MEMORANDUM

SUBJECT: EPA comments on Gasco OU Feasibility Study Report
Gasco Facility, Portland, Oregon
ECSI #84
December 16, 2024

Figure 3-26
Water Budget for the 2016 February-March Wet Period Transient Simulation
Gasco Groundwater Modeling Report
NW Natural Gasco Site

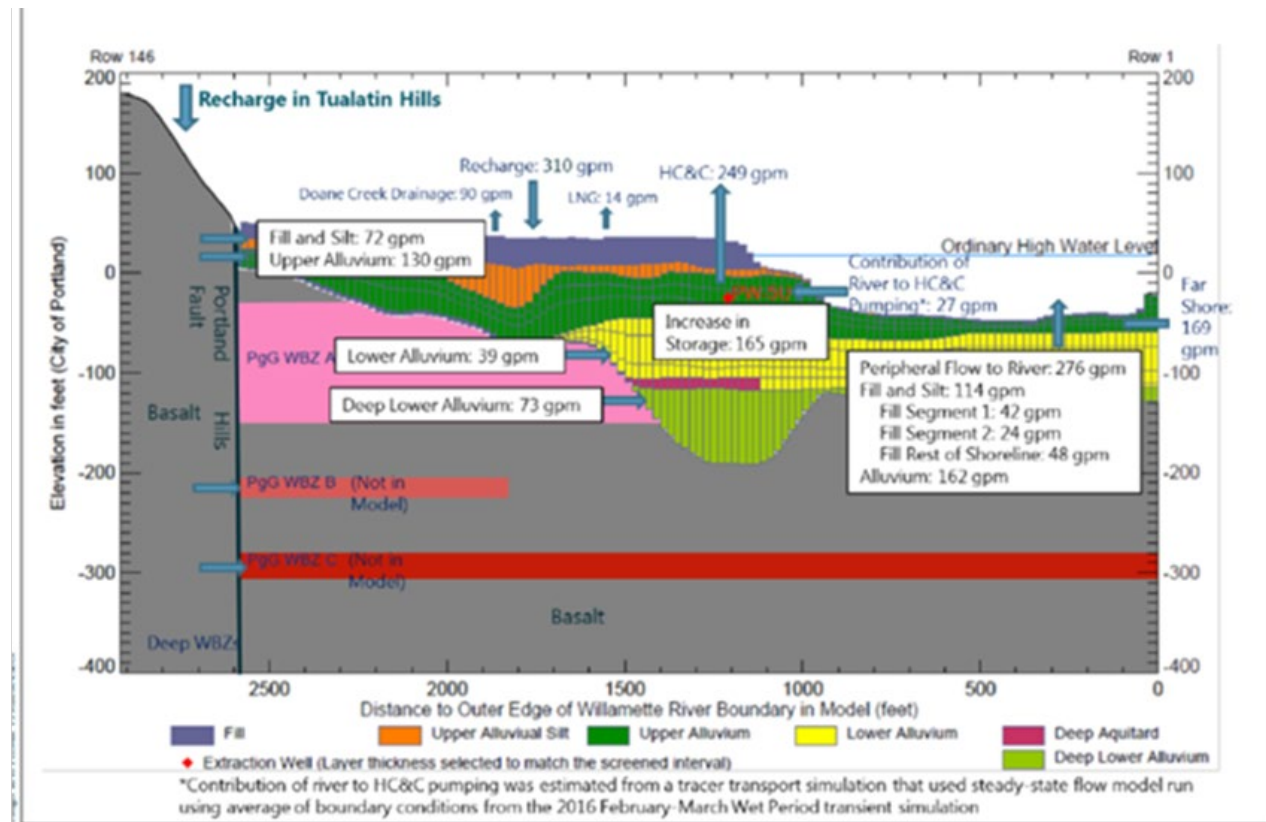
1. A table or cross section figure showing the water budget for the final calibrated model simulation. This table or cross section figure would include all elements of the inputs/outputs identified previously in the Gasco Groundwater Modeling Report calibration (**see example figure 3-26 below from an earlier NW Natural modeling report**).

2. Additional groundwater model water budget quantities added to Table E-6 to understand the full water budget input/outputs simulated under each remedial alternative. For example, adding a row to Table E-6 for precipitation recharge (which would show it be 2 gpm based on an assumed reduction of areal recharge due to added impervious surface if we've interpreted the text correctly) for alternatives 2 through 8. Without having these values either tabulated or discussed in the text, it is difficult to follow. Our interpreted reduction from 310 gpm of recharge to 2 gpm of recharge is based on one sentence on page E-17 that states "Ground-surface capping will minimize groundwater recharge (simulated as 0.5 inch per year, which is equivalent to approximately 2 gpm over the entire Gasco OU)." A row should be added for each component included in figure 3-26 below.

EPA has asked for this groundwater model budget to be provided with their simulations (in cross section, or table format) for the past 3 years. EPA is still waiting for a response to this request.
